*Parliamentary Standing Committee on Public Works*

## REPORT

# REFURBISHMENT AND FITOUT OF JULIANA HOUSE, PHILLIP, ACT

(Fourth Report of 1992)

TYPE - A  
TYPICAL FLOOR LAYOUT STUDY  
PROPOSED REFURBISHMENT & FITOUT  
JULIAHA HOUSE W-2-23 A.C.T.  
DATE: 1/10

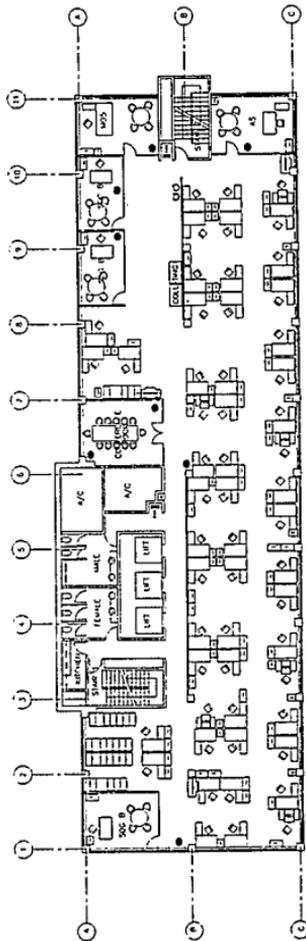
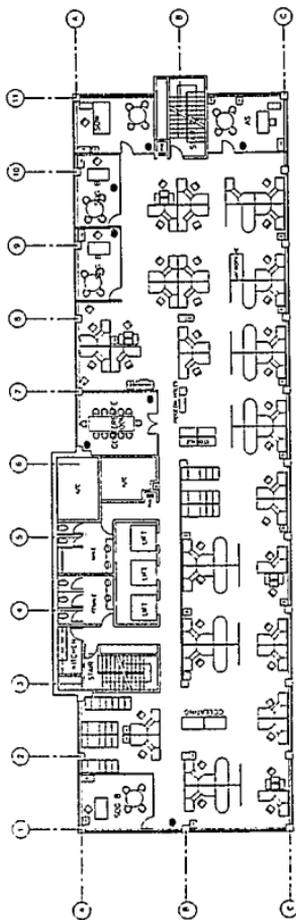
80. At the public inquiry, Mr Hanna was critical of the proposed floor layout, and suggested that the proposal could be further rationalised and made more economical.

81. Mr Hanna demonstrated his point in a presentation to the Committee of an alternative layout, shown at Appendix E, for general office accommodation. His floor layout proposes smaller teams of staff occupying separate areas on a floor. This differed from the AEM proposal of one large area with separate work stations for each staff member. Mr Hanna

suggested to the Committee that his proposal would promote the development of teamwork, a happier environment and allow for greater concentration by the staff. Such a proposition, he believed, would result in cost savings.

82. DHHCS subsequently re-examined Mr Hanna's floor layout and submitted that the department is a dynamic organisation which has undergone, and continues to be subject to, organisational and structural changes. As a result, the department has developed a generic style floor layout and design which can be readily adapted to suit the changing requirements of most of its areas. A feature of this generic fitout style is the location of enclosed offices along one external wall to provide maximum use of open space in terms of general office accommodation, primary and secondary circulation and lighting. (See Appendix F, Drawing F1 - F3).

83. DHHCS further claimed that the compartmentalised layout style proposed by Mr Hanna is similar to that used in the Department prior to its moving to the current generic style layout. The concept was found unsuitable to the department's needs because of its inherent inflexibility to meet its changing structural and organisational requirements.
